Public Safety & Health Committee Board of Representatives

**Item 2– “REVIEW; Collapse of Outdoor Patio at
Allure Apartment Building Located in Harbor Point”**

Presented by
Department of Operations
and Public Safety

**RE: Harbor Points-The Allure: Opinion of Causation-Local Slab Failure
850 Pacific Street, Stamford CT**

Figure 3- PT Step Detail from Original Drawings and HR Report

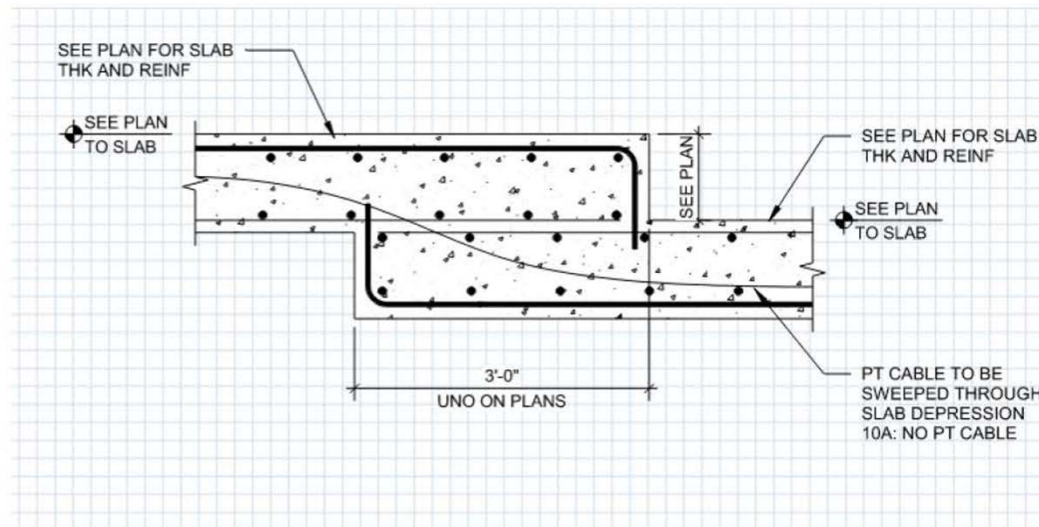
In our recent discussions and a review of the photographs we found that the tendons across the transition zone are missing, resulting in discontinuity of the post tension reinforcing across the slab step and the ability of the slab to span to beyond the transition slab step. Additionally, it appears from the photographs that a horizontal construction joint was placed at the step transition, with no shear transfer mechanism. A 2-inch recess was observed from the underside of the remaining 5th level slab. (See attached SK-4 and Photo).

- Is the identified PT layout correct in the area of the collapsed slab? Are there only supposed to be 3 groups of tendons? The drawings seem to indicate that the tendons should be equally spaced at approximately 3 ft. on center which would indicate that 1 additional band of tendons should have been provided in this area. For the remaining portion of the lower slab that spans west to the exterior wall, is the correct post tensioning layout provided or is a band of tendons missing? If missing, how do you plan to further assess this condition? Can you provide the specific special inspection reports for this location?

NO, THE AS-BUILT CONDITION OF THE PT LAYOUT APPEARS TO BE IN NON-CONFORMANCE WITH THE STRUCTURAL DRAWINGS AND PT SHOP DRAWINGS. NO, THERE SHOULD BE SIX (6) BUNDLES OF PT CABLES EXTENDING FROM LOW SLAB INTO THE HIGH SLAB AT THE STEP AND ANCHORING AT THE EXPANSION JOINT. SLAB ASSESSMENT FOR MISSING PT CABLES WILL BE CONDUCTED IN PHASE 2. ENGINEER-OF-RECORD WAS NOT NOTIFIED BY THE SPECIAL INSPECTOR ABOUT THE NON-CONFORMANCE. NO, WE DO NOT HAVE SPECIAL INSPECTION REPORTS FOR THIS AREA.

- No, the as-built condition of the PT layout does not appear to conform with the structural drawings and PT shop drawings. No, there should be six (6) bundles of PT cables extending from low slab into the high slab at the step and anchoring at the expansion joint. Slab assessment for missing PT cables will be conducted in Phase 2 of the Work Plan. EOR was not notified by the special inspector about the non-conformance, and we do not have special inspection reports for this area.

Figure 9- No Top Steel Crossing Failure Plane Looking North to South at West Failure Plane

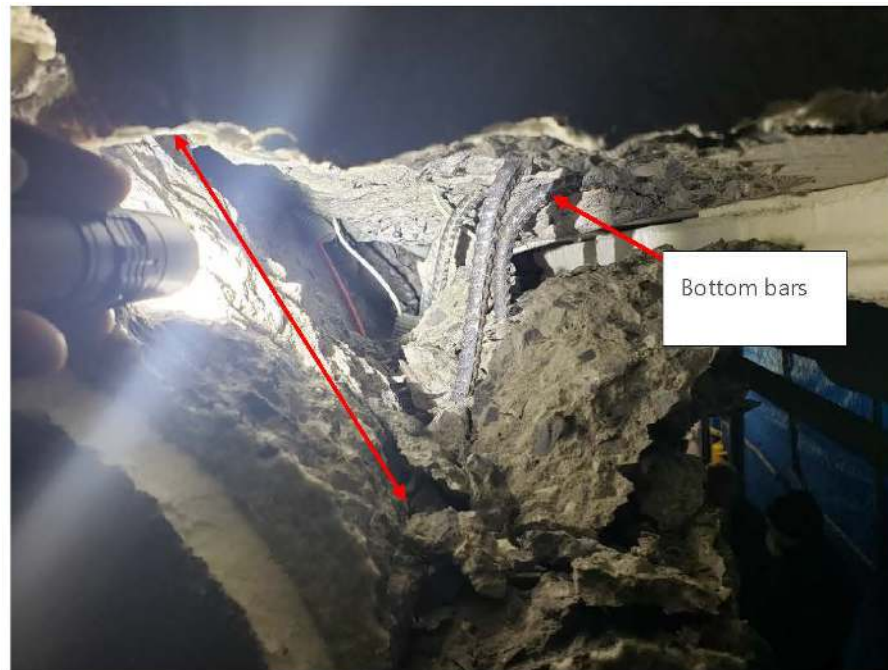
- The construction documents show both a top mat and bottom mat of conventional reinforcement within the PT slab with bars in both directions. In the area of the collapse there is no top steel. Is there supposed to be a top mat of reinforcement? Was this missing steel identified by the special inspector prior to concrete placement? Can you provide the specific special inspection reports for this location? In the event the top steel is missing, how do you plan to identify and assess the extent of the non-confirming steel?

FOR CLARIFICATION, THERE IS ONLY SUPPOSE TO BE #4 MAT AT THE BOTTOM OF THE SLAB IN EACH DIRECTION. ADDITIONAL TOP BARS ARE PROVIDED IN EACH DIRECTION AT COLUMN LOCATIONS. NO, ENGINEER-OF-RECORD WAS NOT NOTIFIED OF ANY MISSING STEEL REINFORCEMENT PRIOR TO CONCRETE PLACEMENT. NO, WE DO NOT HAVE SPECIAL INSPECTION REPORTS FOR THIS LOCATION. SLAB ASSESSMENT FOR MISSING STEEL WILL BE CONDUCTED IN PHASE 2.

- For clarification, there is only supposed to be a #4 size rebar mat at the bottom of the slab in each direction. Additional top bars are provided at column locations in each direction. No, the EOR was not notified of any missing steel reinforcement prior to concrete placement, and we do not have special inspection reports for this location. Slab assessment for missing steel will be conducted in Phase 2 of the Work Plan.

PROJECT NO. 17130-000
ISSUED FOR PERMIT
ISSUED DATE: 10/20/2010
DRAWING TITLE
5TH FLOOR PLAN
DRAWING NUMBER
S105B

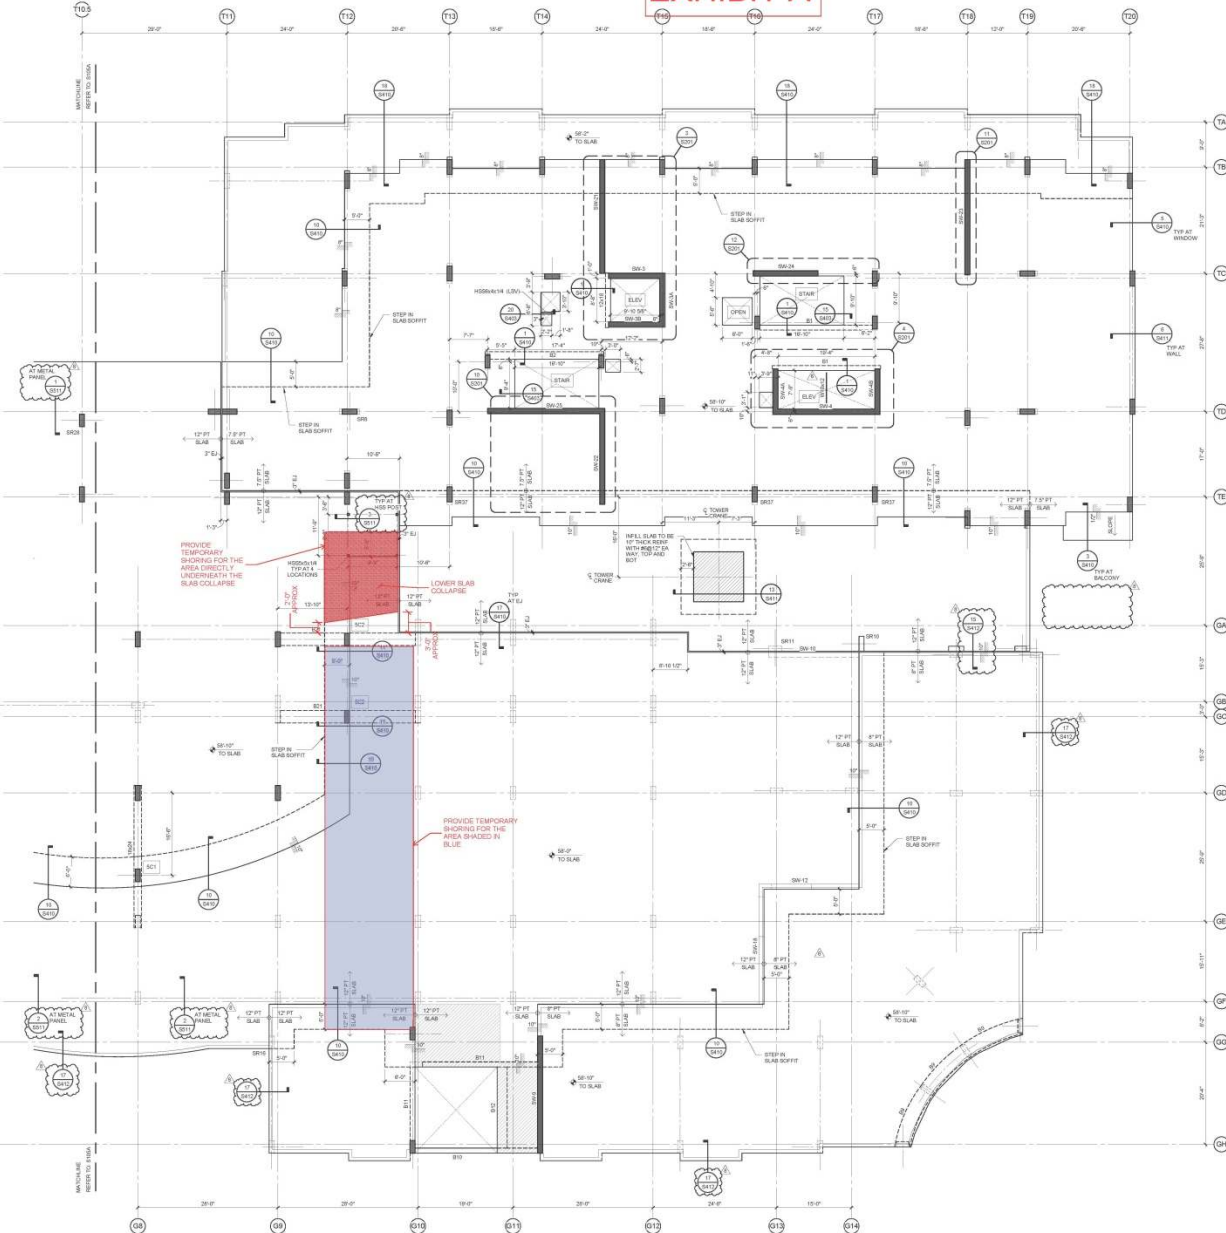
- Did the design team specify the beam between column line T12/T13 along GD that is not shown in the provided drawings? There are not details for it in the provided shop drawings. Provide documentation showing the design revisions adding the beam and reason that this change was made.

THERE WAS A BEAM MARK "B21" AT THIS LOCATION SHOWN ON DRAWINGS DATED "02.23.2018", THIS BEAM WAS SUPPORTING A COLUMN THAT WAS SUPPORTING THE FITNESS CLUB ROOF. THE COLUMN AND BEAM WERE BOTH REMOVED FROM THE IFC DRAWINGS DATED "04.20.2018", SHEET "S105.B", BECAUSE OF ARCHITECTURAL CHANGES. HOWEVER, IT APPEARS THAT THE CONCRETE BEAM (B21) WAS CONSTRUCTED PER DRAWINGS DATED "02.23.2018". DRAWINGS DATED 02.23.2018 WILL BE PROVIDED.

- There was a beam mark "B21" at the questioned location shown on drawings dated "02.23.2018", and this beam was designed to support a column for the fitness club roof. The column and beam were both removed from the "IFC" drawings dated "04.20.2018", Sheet "S105.B", because of architectural changes. However, it appears that the concrete beam (B21) was constructed per drawings dated "02.23.2018".
